SUTHERLAND SHIRE COUNCIL ASSESSMENT REPORT

Panel Reference	PPSSSH-11
DA Number	DA19/0786
LGA	Sutherland Shire
Proposed Development	Demolition of existing structures, construction of a medical centre
Street Address	Lots 7 to 9 DP 8147, 398 to 402 Kingsway and 27 Flide Street, Caringbah
Applicant/Owner	Irwin Medical Developments Pty Ltd
Date of DA lodgement	22 October 2019
Number of Submissions	12
Recommendation	Refusal
Regional Development Criteria (Schedule 7 of the SEPP (State and Regional Development) 2011	State Environmental Planning Policy (State and Regional Development) 2011, requires this application to be referred to the Sydney South Planning Panel (SSPP) as the development has a capital investment value of more than \$5 million and as such is nominated under Schedule 7 "Regionally significant development" of SEPP (State and Regional Development) 2011. The application submitted to Council nominates the value of the project as \$20,465,000.

That Development Application No. DA19/0786 for Demolition of existing structures and construction of a medical centre at Lots 7 to 9 and 37 DP 8147 398 to 402 Kingsway and Flide Street, Caringbah is determined by the refusal of developm

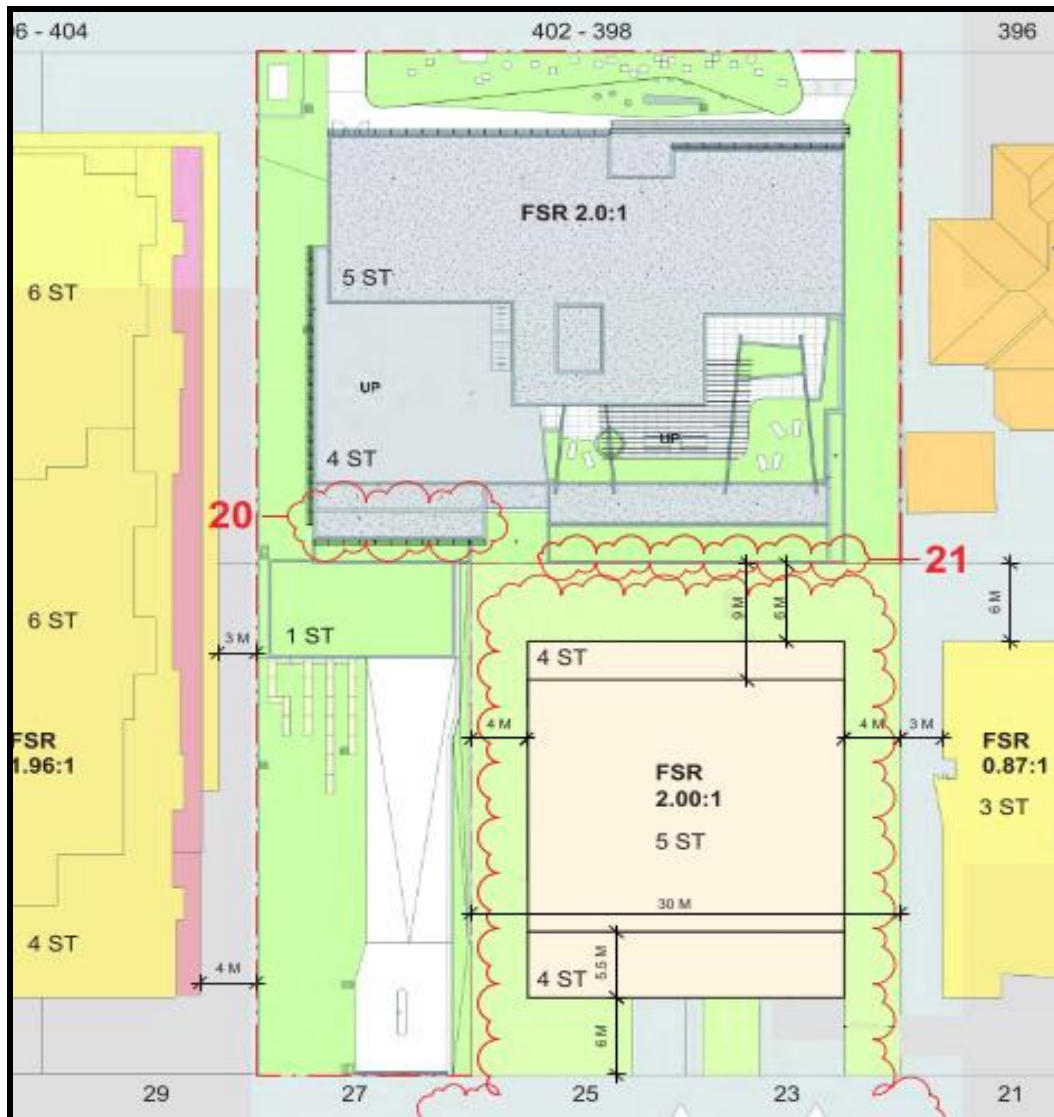
The isolated lots (23 and 25 Flide Street) have an individual frontage of 15.24m or combined frontage of 30.48m. The applicant provided the following schematic drawings showing three potential options for the redevelopment of 23 and 25 Flide Street if redeveloped in the future:

A 3 storey residential flat building constructed on each individual lot. This drawing reflects a building footprint replicated from the building that was proposed under the Affordable Housing SEPP approved on 8 May 2018 by the Land and Environment Court.

A 5 storey residential flat building with a floor space area of 2:1 and with habitable setbacks from the rear boundary as recommended by the ADG.

Based on the information provided, varying the amalgamation and building envelope plan for Site 14 will result in a building situated on an irregular shaped lot that will have unacceptable impacts on surrounding properties and the street, in terms of bulk and scale, visual, building separation, basement and landscape setbacks. If the building design was amended to resolve many of these issues, the FSR permitted on the site would unlikely be realised. In this case, the proposal has not demonstrated that breaking the amalgamation and BEP envisaged for Site 14 will result in a better alternative outcome for the Caringbah Medical Precinct.
